APPLICATION NO.	FILING DATE	FIRST NAMED INVENTOR	ATTORNEY DOCKET NO.	CONFIRMATION NO.
10/619,453	07/16/2003	Makoto Taniguchi	116602	7702
25944	7590	07/12/2005	EXAMINER	
OLIFF & BERRIDGE, PLC P.O. BOX 19928 ALEXANDRIA, VA 22320			GONZALEZ, JULIO C	
			ART UNIT	PAPER NUMBER
			2834

Office Action Summary	Application No. 10/619,453	Applicant(s) TANIGUCHI, MAKOTO	
	Examiner Julio C. Gonzalez	Art Unit 2834

DETAILED ACTION

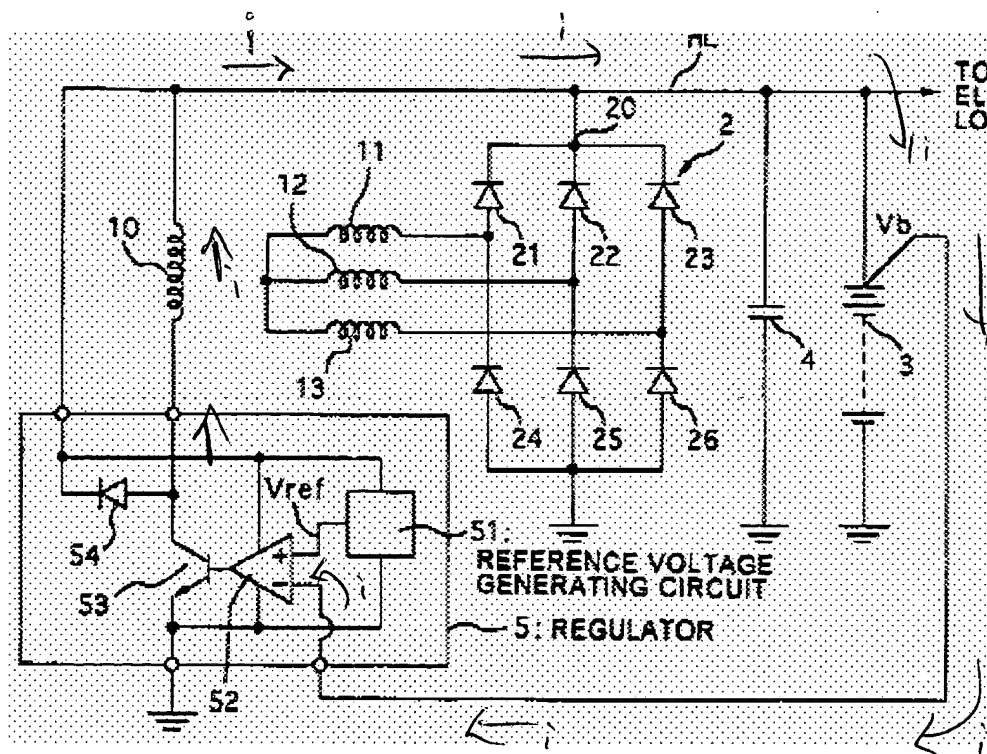
On the other hand, Iwatani et al discloses for the purpose of efficiently reducing the load of a vehicle engine, a generator 1 being excited by field winding 102, a single power supply 8 connected to an output terminal of the generator 1 (see figure 1) and the power supply 8 provides a current to the field winding 102 (column 1, lines 48-50; column 4, lines 38-40, 62-64). Moreover, it is disclosed that the power supply 8 is chargeable (column 2, lines 19, 20) and switches are used to turn on/off the power being supplied to the field winding (column 2, lines 11-14).
